Title of Change:	Mold Lock Improvement for UF3N120007K4S Lead Frame.
Effective date:	11 Mar 2026
Contact information:	Contact your local onsemi Sales Office
Type of notification:	This Product Bulletin is for notification purposes only. onsemi will proceed with implementation of this change upon publication of this Product Bulletin.
Change Category:	Assembly Change
Change Sub-Category(s):	Additional mold lock from 270deg to 360deg in existing Ag plated lead frame

PCN#: PB27345X
Issue Date: Mar 11, 2026

Current Lead Frame

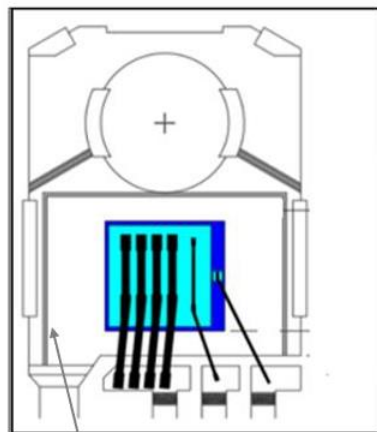
Mold lock on 3-sides in current lead frame

Add Bottom Mold Lock to Current Lead Frame

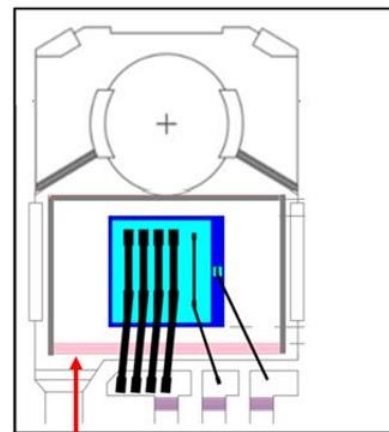
onsemi wishes to inform customers of the additional mold lock feature at the bottom of the existing lead frame of UF3N120007K4S to improve the yield of the product without delamination (2x-3x higher output).

Bottom Mold lock
